Public Works and Government Services Canada	Winnipeg, Manitoba Global Affairs Canada (GAC) Regional Office Fit-Up	Addendum No. 5 Page 1 of 3
Project No.: R.104185		June 17, 2021

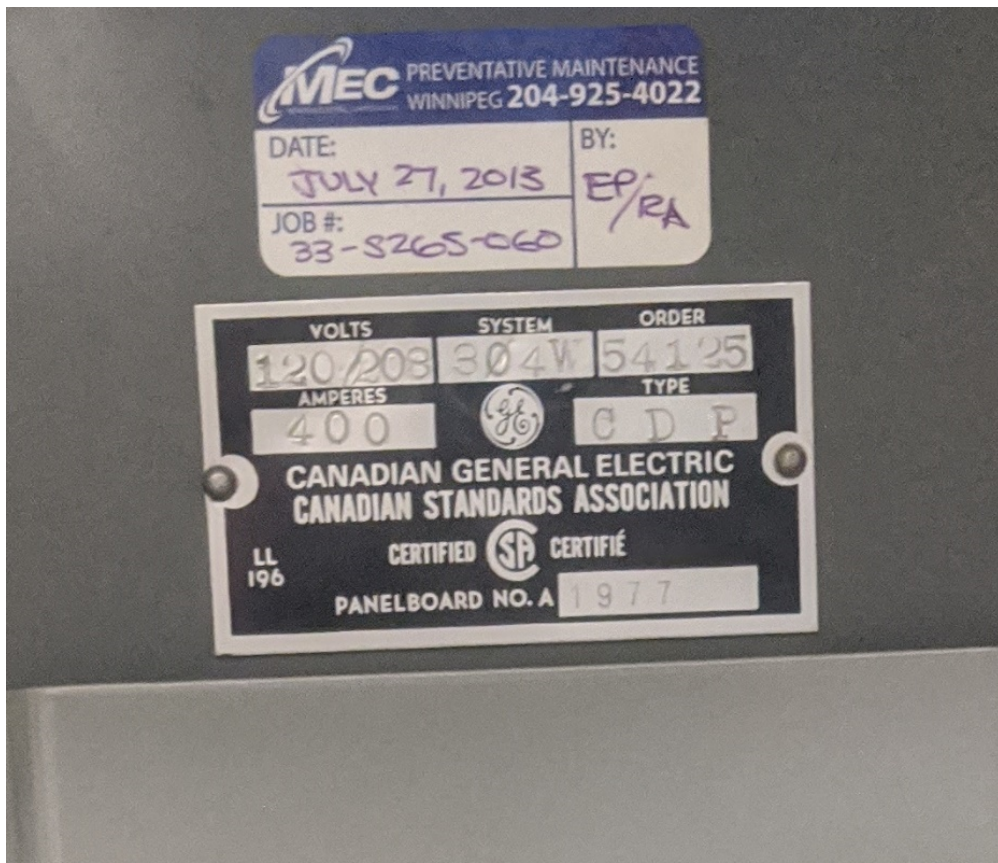
- 5.3.1 Section 09 65 00 – Resilient Flooring  
Paragraph 2.1.3.12 – Materials Resilient Base (RB-1):  
.12 Height: 101mm high (4" high)
- 5.3.2 Section 09 65 00 – Resilient Flooring  
Paragraph 3.4.4 – Application: Flooring – Omit:  
.4 ~~Heat weld seams of linoleum sheet flooring in accordance with manufacturer's printed instructions.~~
